# CITY PLANNING COMMISSION

**APPLICATION:** A. Plan Review of a 2,920 sq. ft., 74 seat fast-food restaurant with one drive-through window on 0.9+ acres in the General Commercial-Review (C-2-R) Zone

**PROPOSAL:** The applicant is requesting the necessary entitlements to construct a Kentucky Fried Chicken fast-food restaurant with a drive-through window

PROJECT EVALUATION: Staff has the following comments:

REVISION  
SITE PLAN  
SHEET

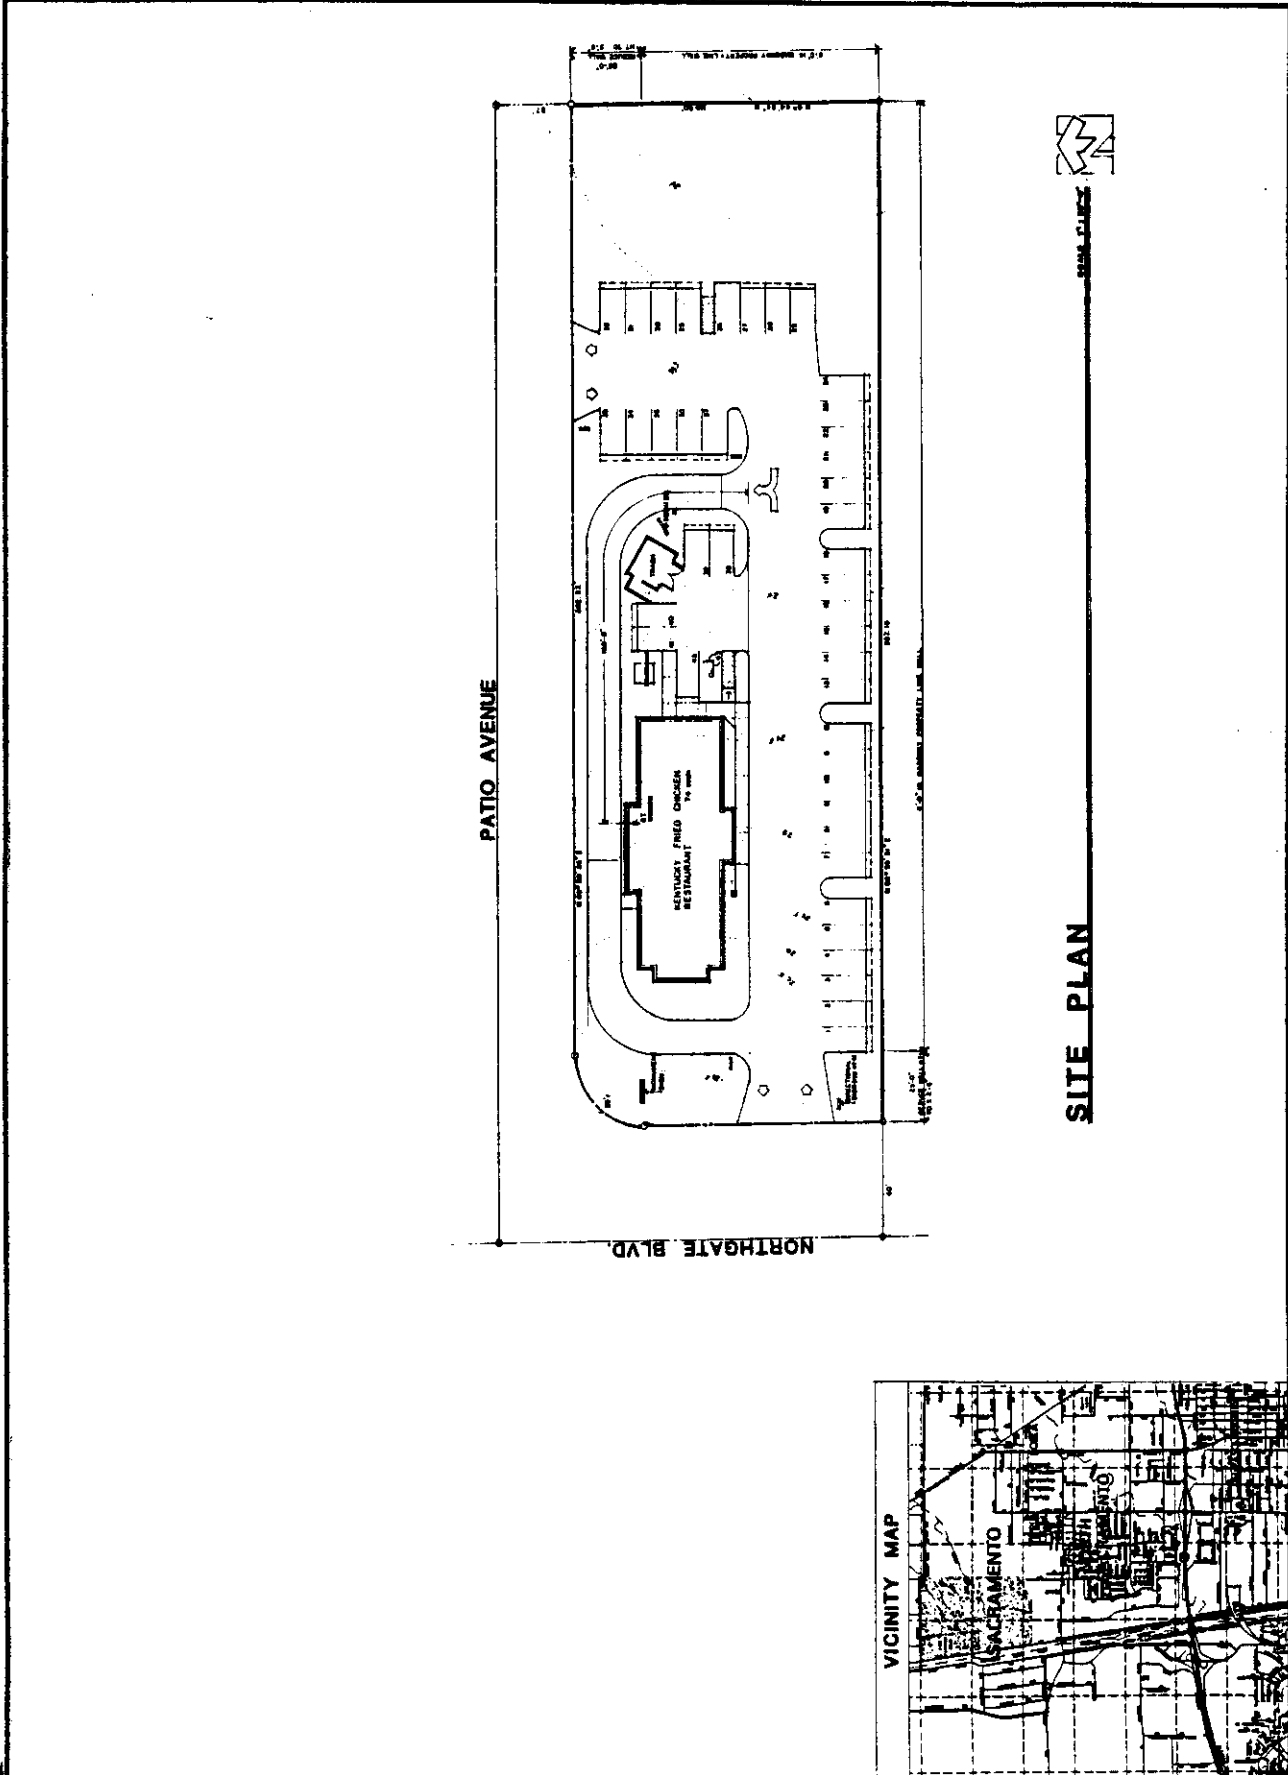
2. **Trash Enclosure:** The applicant's site plans show a trash enclosure. Staff recommends that the trash enclosure comply with the attached Trash Enclosure Guidelines (Exhibit A).

3. **Walls:** A 6-foot high solid wall is shown along the south and east property line. The method of construction and type of wall appears to be masonry block on a concrete foundation. Staff recommends that the wall be constructed of a decorative material and color compatible with the restaurant's design. The wall shall observe the height limits within the 25-foot setback area off Northgate Boulevard and Patio Avenue.

4. **Driveway for Drive-Through Window:** Staff has discussed with the applicant a potential conflict with pedestrian traffic coming off Patio Drive across the drive-through driveway to the north door. The office/warehouse development and future use by Golden Gate University to the north of Patio Avenue may create an increase in pedestrian traffic across the drive-through driveway. Staff recommends that the applicant revise his site plan to provide intensive landscaping along Patio Avenue in the 5-foot planter adjacent to the sidewalk to deter through traffic. Another alternative is to provide a walkway with railing to prevent access adjacent to the north side of the building leading from the Northgate Boulevard.

5. **Utility Transformer and Meters:** Staff recommends that any utility distribution facilities be screened so to not be visible off-site. The SMUD transformer proposed between the building and trash enclosure shall be screened with materials or landscaping compatible with the building.

1. Increased landscape strip along the south property line to 6 1/2 feet. These may require redesigning stalls 1 to 12 to a 60 degree angle.
2. Eliminate the 2 stalls, number 32 and 33 closest to Patio Avenue at the driveway so no vehicles back into traffic entering or exiting the site. The total area free of parking should be 20-foot deep as measured from the Patio Avenue right-of-way property line. Staff recommends landscaping in the area which does not create a visibility problem.
3. The revised site plan shall show all dimensions of driveways, parking spaces, building setbacks and landscaped areas. Due to the limited area of the site, dimensions are necessary to determine viability of the site layout.

The drive-through window requires an external speaker unit. Staff recommends that the volume on the loudspeaker be controlled so to not be audible to adjacent residentially zoned property. The menu board may required readjustment to face northward so that the loudspeaker projects to the north and not east as shown.

2. Six-foot high decorative walls shall be shown on a revised site plan adjacent to residential zones compatible in color with the restaurant.
3. All driveways shall be designed to City standards for commercial driveways. All improvements to the public right-of-way shall be reviewed and approved by the City Engineer's Office.

4. The trash enclosure shall be designed according to the attached trash enclosure guidelines (Exhibit A).
5. The applicant shall restrict access off Patio Avenue across the drive-through driveway by use of intensive landscaping or providing railing or barrier along the north building elevation opposite the north doorway. An "Exit Only" doorway may be most appropriate with no external door hardware.

6. The eastern portion of the lot shall be landscaped with grass, irrigated and maintained in a litter free condition.
7. The parking lot shall delete stalls 32 and 33 closest to Patio Avenue so that a minimum of 20 feet of vehicle clear area is established off Patio Avenue. Landscaping shall be low profile so to not provide visibility problems.

# LANDSCAPE PLAN

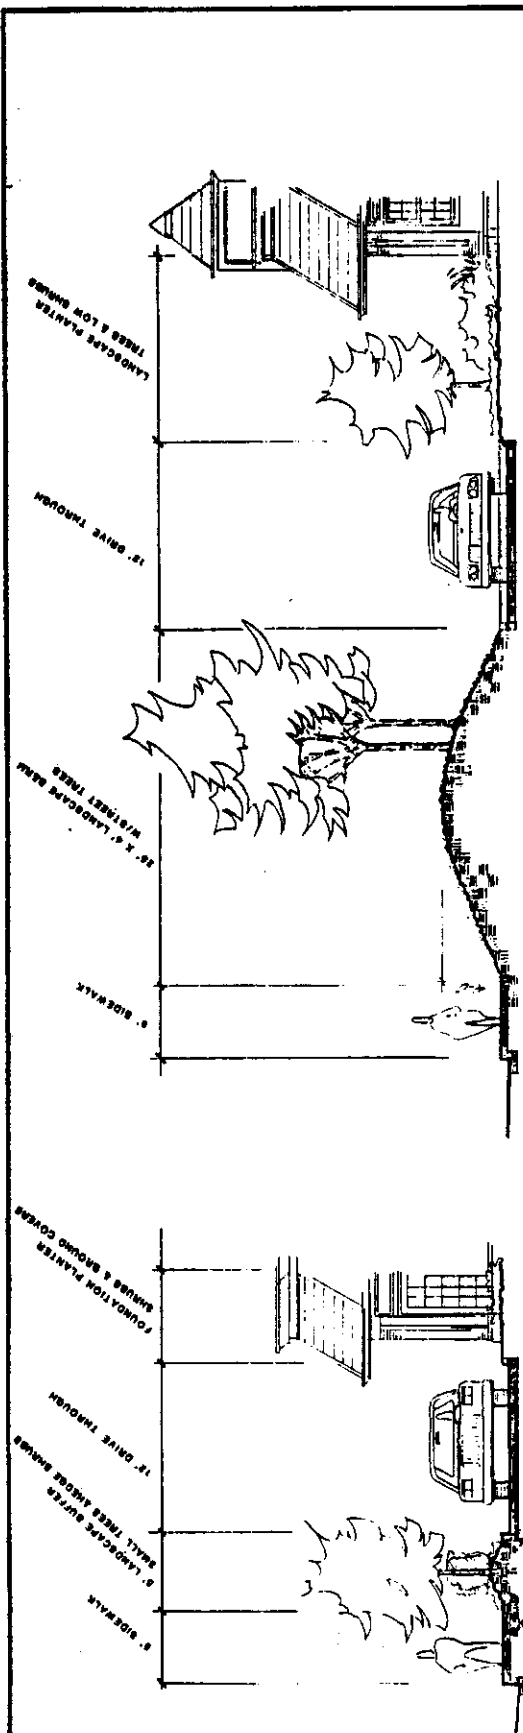
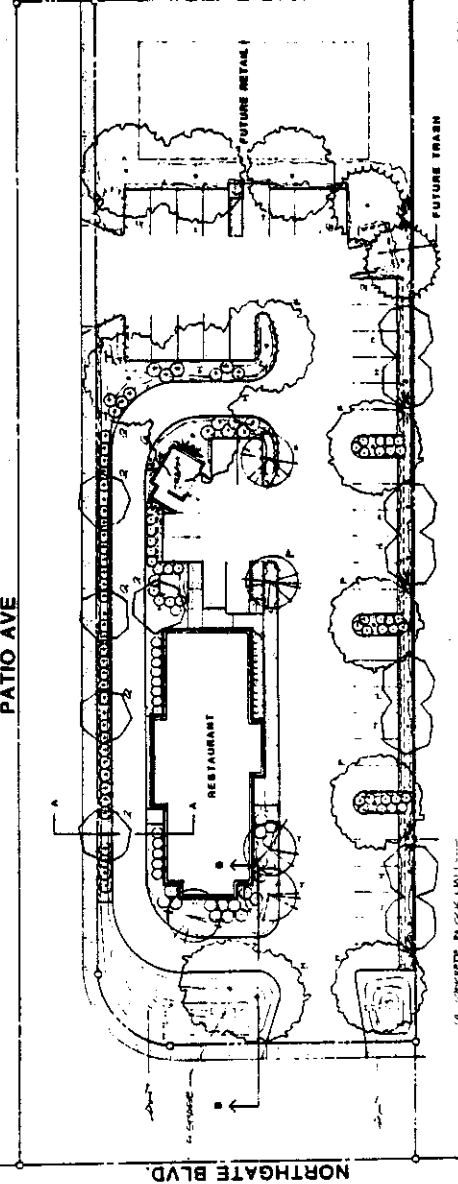
1. **South Property Line Wall:** Staff notes that deciduous trees are shown along the landscape area adjacent to the south property line. Staff recommends use of evergreen trees for shading adjacent to the residentially zoned property in place of the deciduous trees. It should be noted the landscape planter adjacent to the south property line will require an increase in width from 5 feet to 6 1/2 feet allowing 6 inches for a wall, 2 feet for vehicle overhang and 4 feet of clear, unobstructed landscaping between the wall face and vehicle overhang area.

2. **Trees Shading Requirement:** The applicant's preliminary landscape plan appears to meet the 50 percent shading coverage requirement. The applicant shall maintain the coverage when selecting evergreen trees along the south property line landscape strip.

3. **Curb and Wheel Stops:** The applicant shows the use of 6 inch concrete curb with vehicle overhang. Staff recommends that no portable concrete wheel stop be used on the site and that 6-inch concrete curb be used adjacent to all landscape areas.

4. **Bark Mulch:** Groundcover under shrubbery on the landscape plan is not clearly identified. Staff notes that within the landscape street frontages, living groundcover is required. Staff recommends that all exposed areas be planted with living groundcover with no use of bark, mulch or rock.

5. Future Retail Area: The applicant's landscape plan shows the eastern portion of the lot as a possible retail store site. Until the area is developed, staff recommends that the area be landscaped with grass, irrigated during the summer and maintained in a weed- and litter-free condition. Fencing off the area may be appropriate if loitering or security problems arise. Staff recommends the revised landscape plan show the type of groundcover. Irrigation plans can show use of a hose bib to service the area unless automatic irrigation is desired by the applicant. The applicant indicated the use of a rye grass with high mowing and weekly watering during the summer months as an option. Specifics remain to be worked out between the owner and applicant.

1. Revised landscaping, shading, and irrigation plans for the site shall be submitted for Staff review and approval prior to issuance of building permits.

8. Parking lot shall comply with the 50 percent shading requirement. A minimum 4-foot planter strip and 2 additional feet of planter for vehicle overhang shall be provided adjacent to the wall.

9. No bark mulch is to be used on the site. Living groundcover is required under shrubbery on the revised landscape plans.
10. Landscaping shall be designed to comply with minimum visibility requirements for all driveways and intersections.

# SIGNAGE

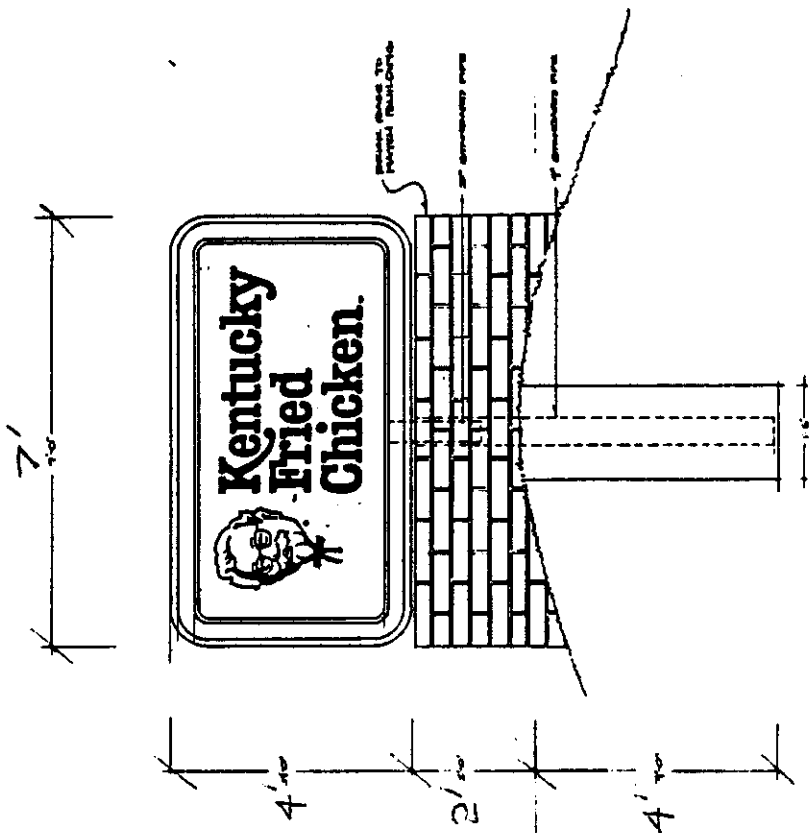
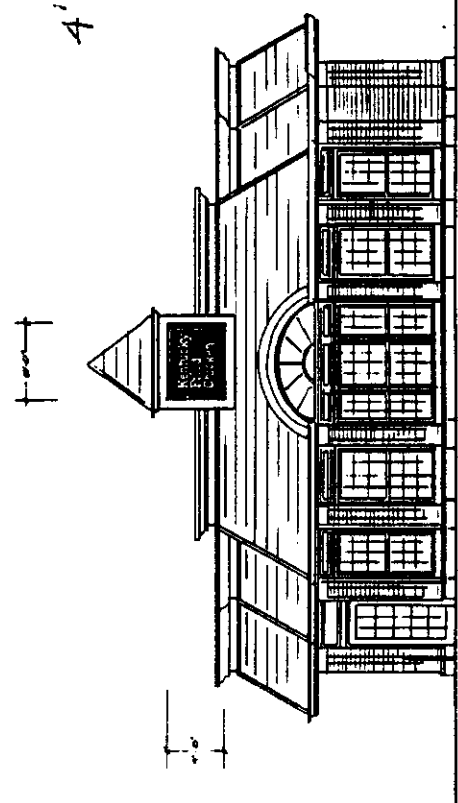
1. Monument Sign: The previous permit (P86-356) allows one freestanding monument no higher than 6 feet as measured from the top of sidewalk. The proposed monument sign is located on top of a 4-foot high berm resulting in a 10-foot height. The monument sign shall be redesigned or relocated to comply with the 6-foot height limit.

2. Logos on Directional and Informational Signs: The portrait of the "Colonel" is shown on the directional and informational signs. The applicant should be aware that the logo is not allowed on directional signs as per the City Sign Ordinance. The logo is included in calculating attached and detached signage in addition to any letters.

3. Welcome/Enter Sign: The sign showing the logo and words "Welcome/Enter" should be downsized from 5-feet high, 3 1/2-foot wide size to a more modest size of no greater than 4-square feet of sign area and 4 feet in height. The signs should be set back more than 10 feet from the public right-of-way. The words "Welcome/Thank You" and the logo are not allowed as part of the directional sign. Staff recommends that the applicant submit a signage program reflecting all above concerns for review and approval by the Planning Director prior to issuance of sign permits.

11. Utility meters and transformers shall be screened from roadway view.
12. Bicycle parking shall be provided as per the City Parking Ordinance.
13. A uniform signage program shall be submitted for review and approval by the Staff prior to issuance of sign permits. The monument sign shall not exceed 6 feet in height as measured from top of sidewalk.
